ATTACHMENT A

Marked-Up Pages

9502010241 950127  
PDR ADDCK 05000237  
P PDR

ATTACHMENT B

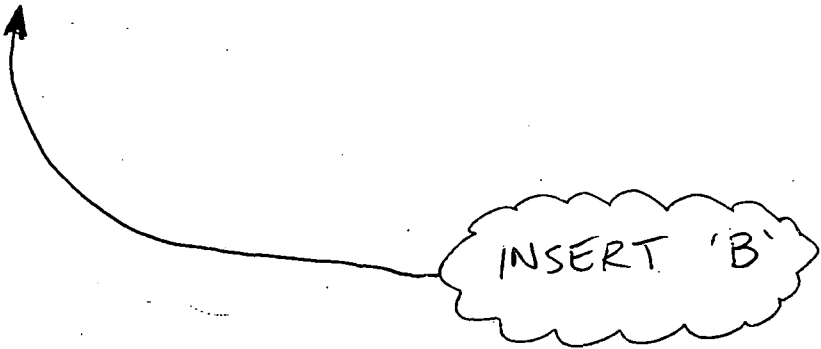
INSERT A

D. Surveillance Requirements for inservice inspection and testing of ASME Code Class 1, 2, and 3 components shall be applicable as follows:

1. Inservice Inspection of ASME Code Class 1, 2, and 3 components and inservice testing of ASME Code Class 1, 2, and 3 pumps and valves shall be performed in accordance with Section XI of the ASME Boiler and Pressure Vessel Code and applicable Addenda as required by 10 CFR Part 50, Section 50.55a(g) and 50.55a(f), respectively, except where specific written relief has been granted by the Commission pursuant to 10 CFR Part 50, Section 50.55a(g)(6)(i) or 50.55a(f)(6)(i), respectively.
2. Surveillance intervals specified in Section XI of the ASME Boiler and Pressure Vessel Code and applicable Addenda for the inservice inspection and testing activities required by the ASME Boiler and Pressure Vessel Code and applicable Addenda shall be applicable as follows in these Technical Specifications:
